Re: Hearst Elementary School
DCRA Building Permit Tracking Number B1501123
Zoning Reviewer Comments

Hearst Elementary Building CD
3950 37th Street NW, Washington DC
Building Permit # B1501123

RMc response to the DCRA Zoning comments dated June 16, 2015 via phone conversation with Mr. David Vollin. The following are the comments and design team response;

A200

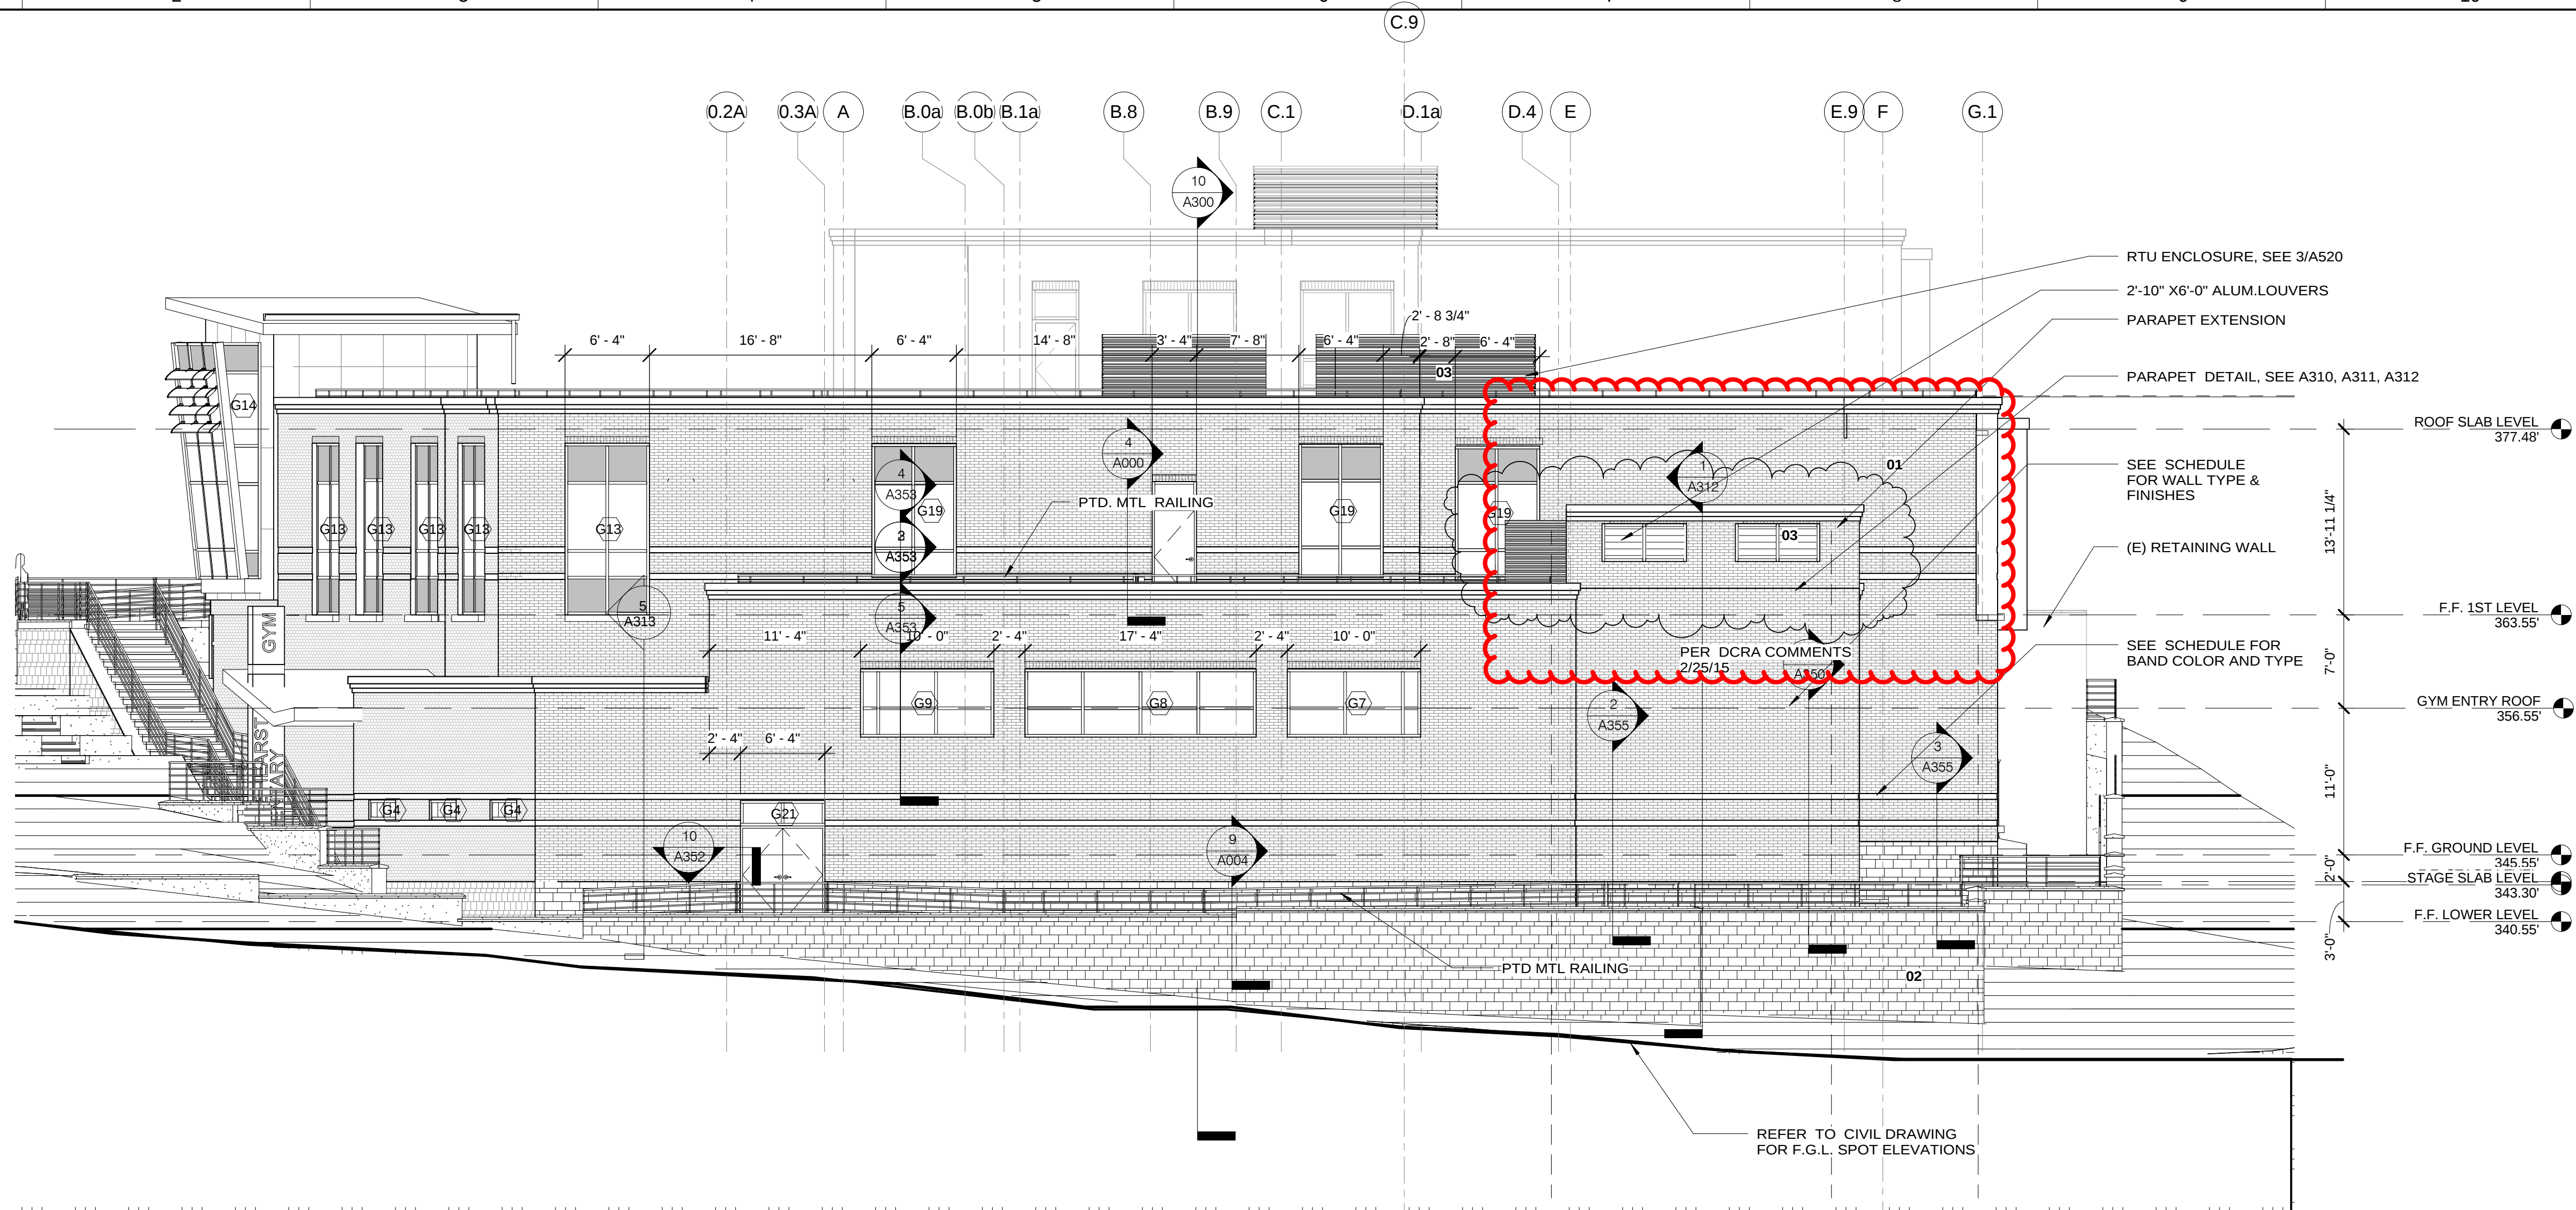
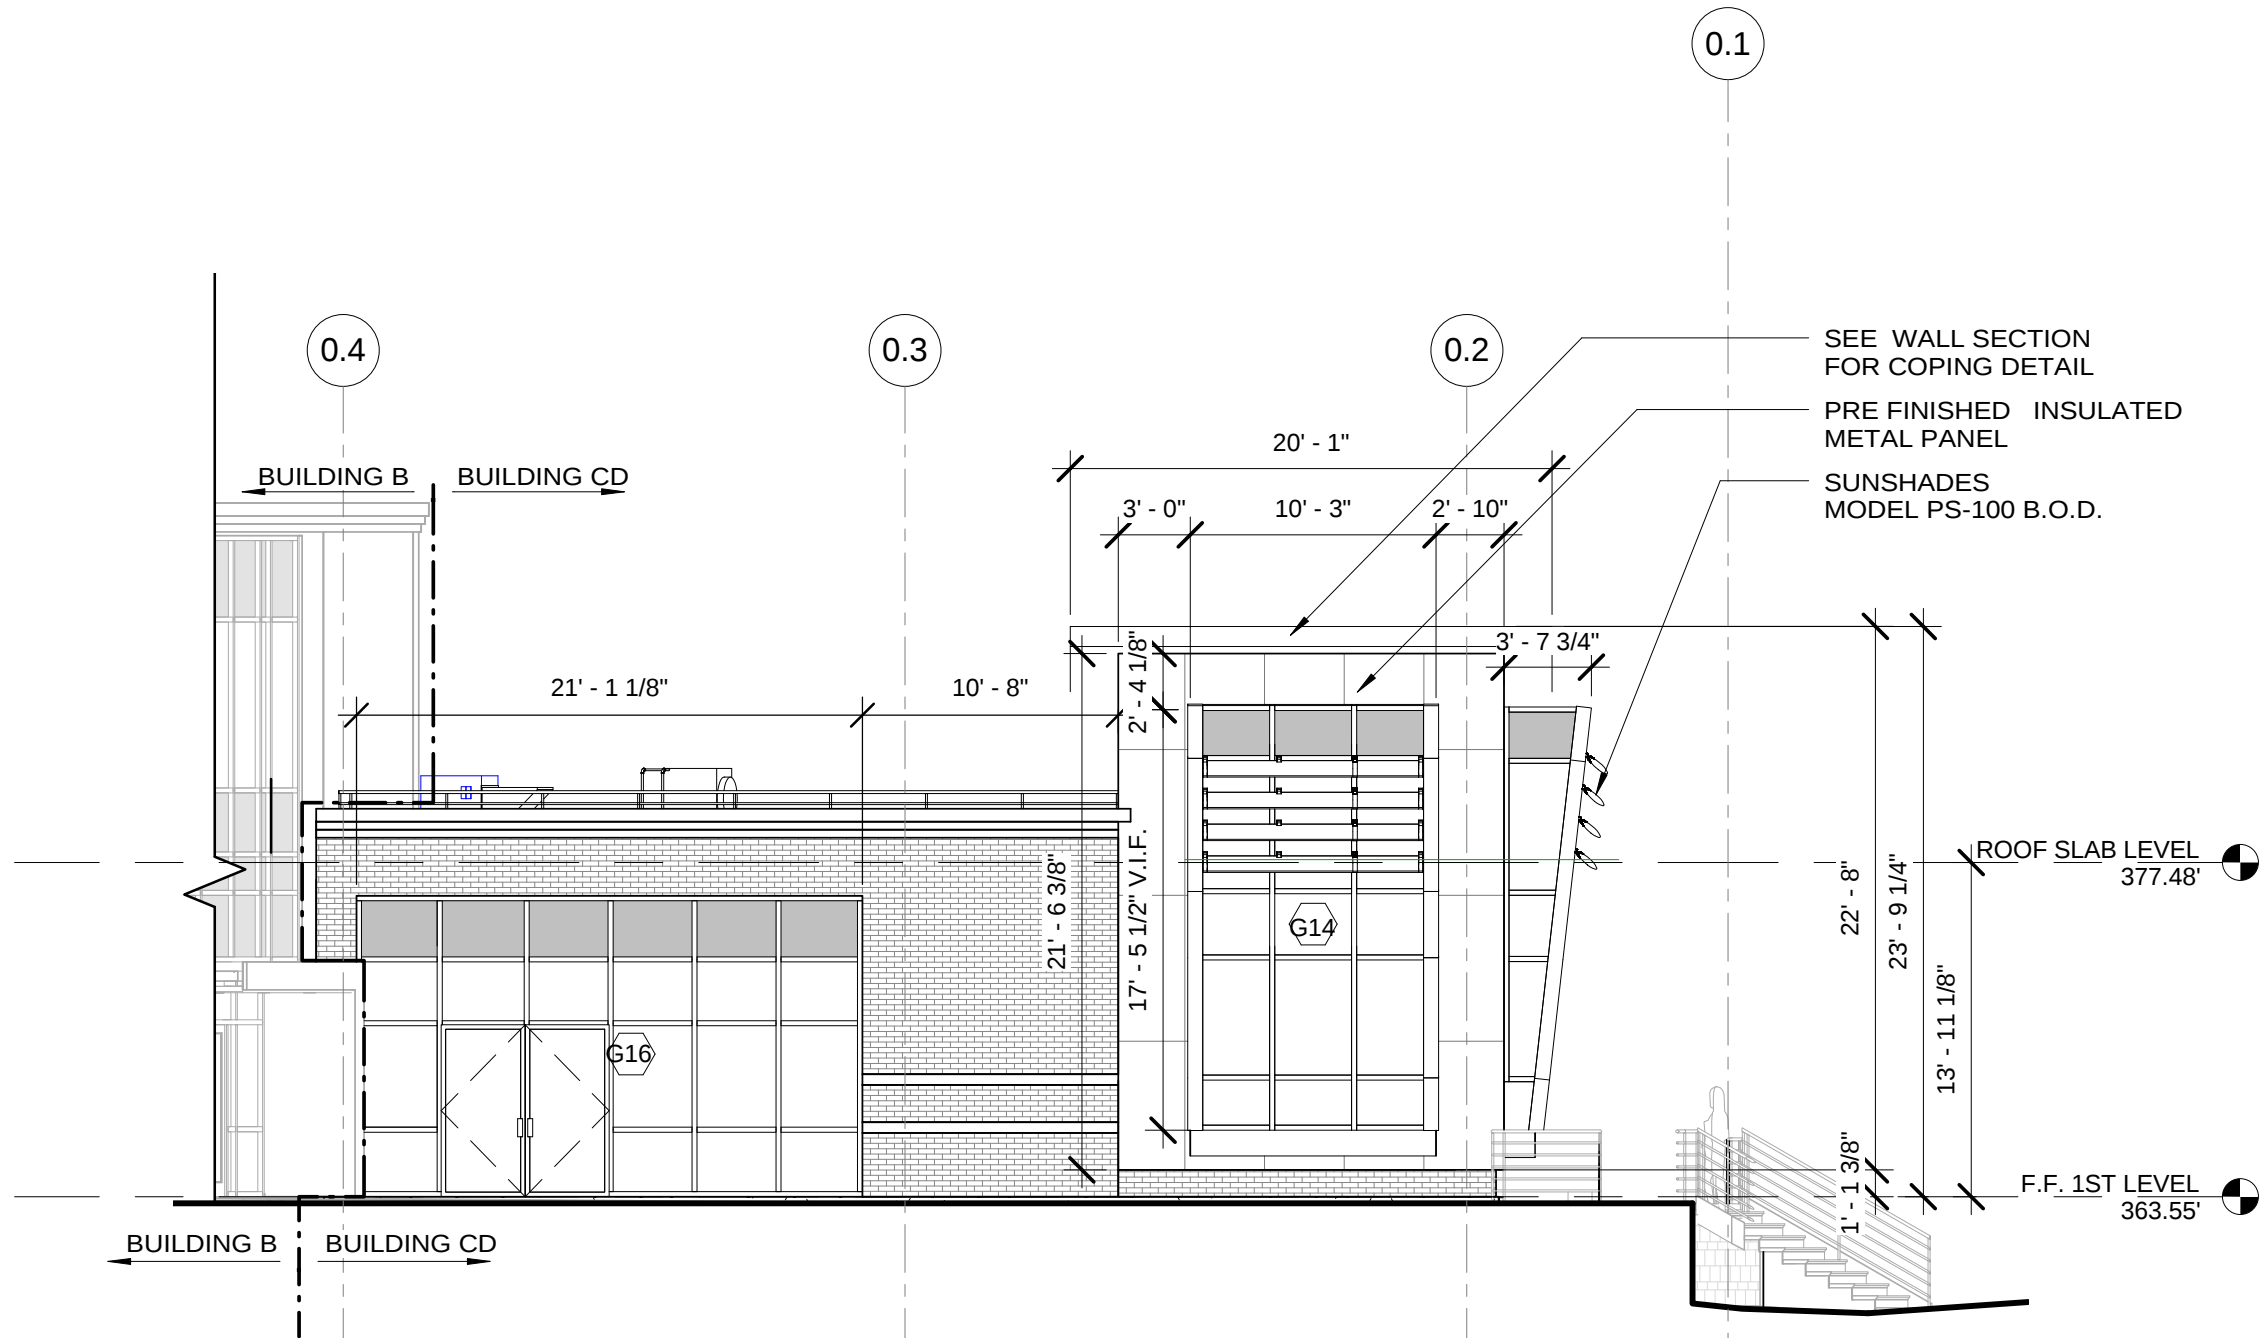
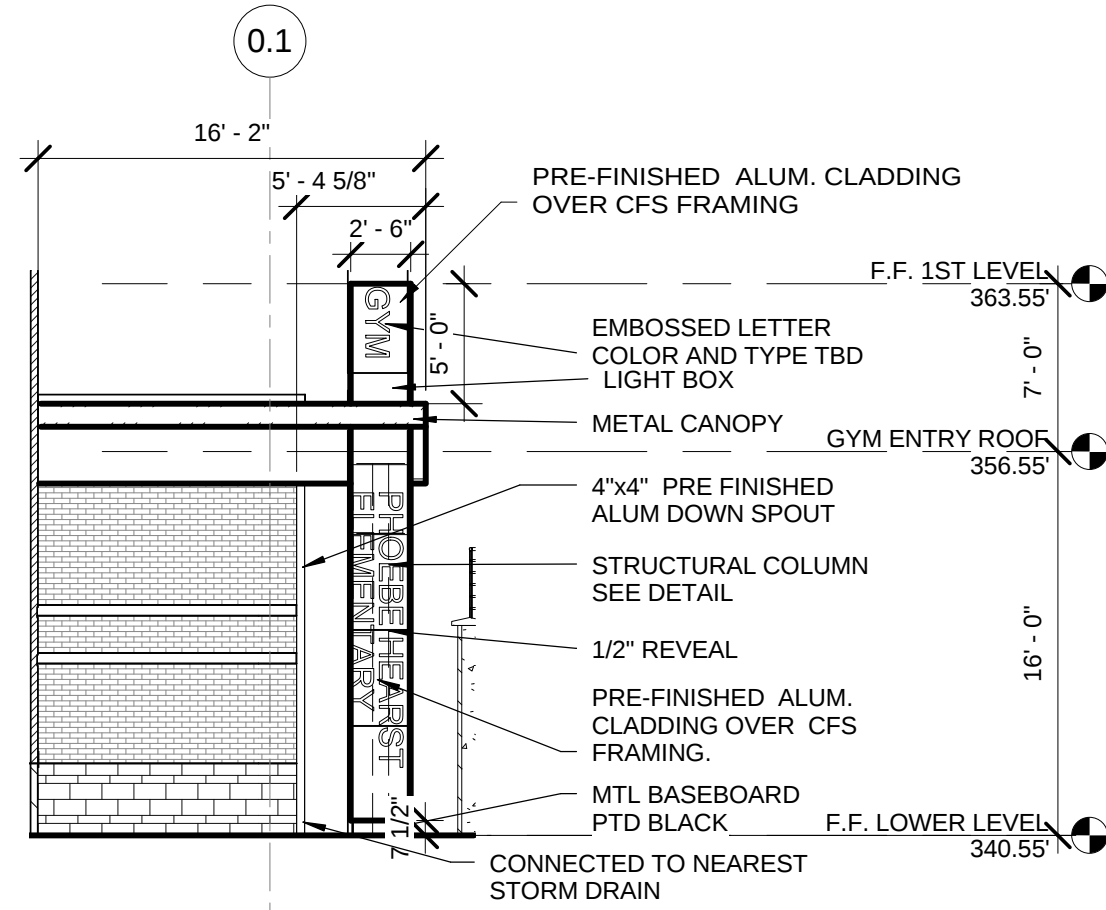
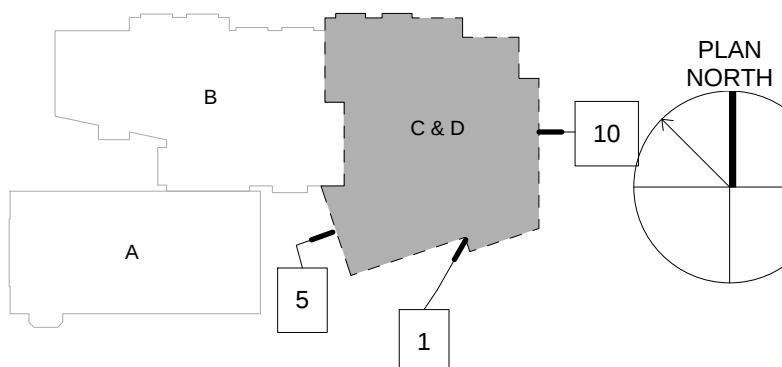
- 1. All required screening and mechanical equipment shall have a 1 to 1 setback from all exterior walls or BZA is required**

After waiting for few months, we received comments via phone call from Mr. David Vollin, Tuesday, June 16, 2015, regarding the 1:1 ratio. According to Mr. Vollin, the parapet we showed in our drawings shows extension only in the area of the mechanical equipment where it requires a 1:1 setback from the exterior wall, and still not compliance apparently the parapet needs to be extended to the perimeter of the roof structure, whereby increasing the length and height of the whole parapet above the roof level.

PER DCRA ZONING COMMENTS

In response to the DCRA comment listed above, sent by Quinten L. Washington, dated February 11, 2015, Design team responded to the comment dated 3/17/15 with updated drawings, based on our interpretation of the zoning regulation 411 and 770.6, to show drawing revisions in the mechanical screen at the North East corner of the building which is the subject of the comments. See attached A104, A200, and A201.
